**N6733B-01**

**S E R V I C E N O T E**

**N6733B 50W DC Power Module**

**Current Measurement accuracy is out of specification when there is voltage being sourced at the output terminals.**

Location of C36 and C37

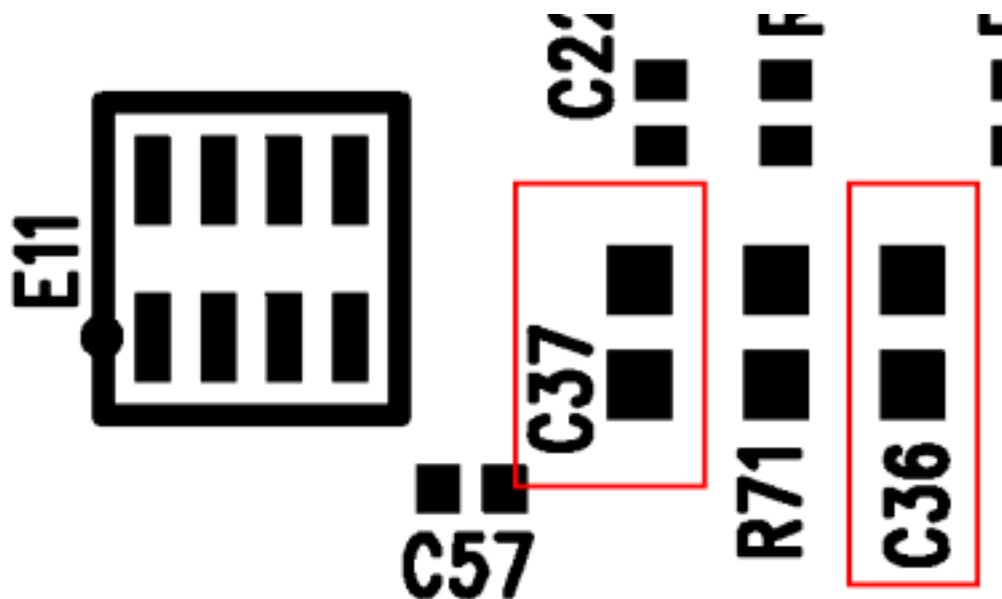
Due to some noise filtering issues, the current measurement accuracy will be out of specification by a fixed offset when there is a voltage being sourced at the output terminals. If the output is shorted, the current measurement accuracy will be within specifications. Please note that the performance verification test will not catch this.

If this measurement is out of specification, replace capacitors C36 and C37 on the DPM assembly (this is the assembly that is vertically mounted in the unit that looks similar to a PC memory module) with part number 0160-7809. After the capacitors are changed, the unit will require re-calibration. After the capacitors are replaced, check the make sure that the unit is in specification by applying 75% of the full voltage range while attached to a load drawing 50 mA to 70 mA. If the current measurement is within the specification, then the unit has been repaired.

Test to see if the module is out of specification by applying 75% of full scale voltage while drawing 50 to 70 mA . Compare the reading to what it should be via the current measurement accuracy spec. If the current measurement is within specification then the capacitors will not need to be changed.
